Product Change Notification / GBNG-17ZWEX736

CCB 4959 Initial Notice: Qualification of MMT as a new assembly site for selected SMSC LAN91C11xx device family available in 128L TQFP (14x14x1mm) package.

CCB 4959
Pre and Post Change Summary
PCN #: GBNG-17ZWEX736

ASE

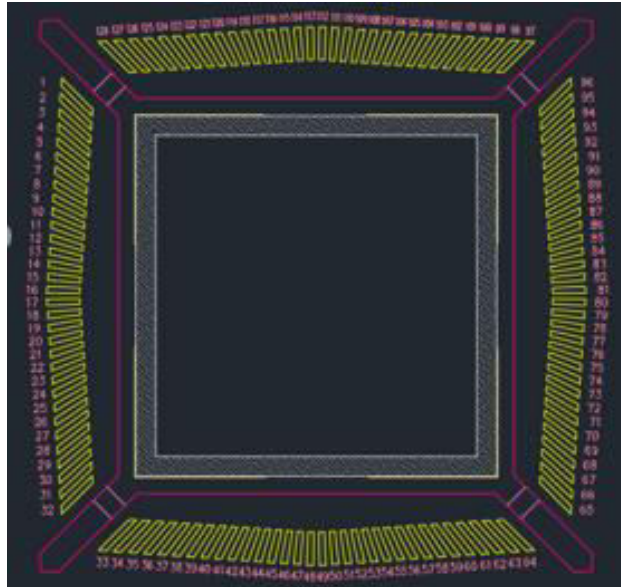
Lead frame paddle size	240 x 240 mils
Lead frame DAP surface prep	Double Ring

MMT

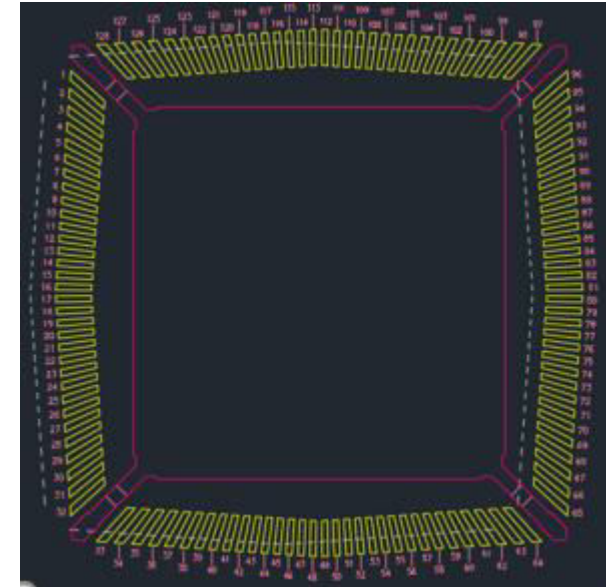
Lead frame paddle size	252 x 252 mils
Lead frame DAP surface prep	Bare Cu
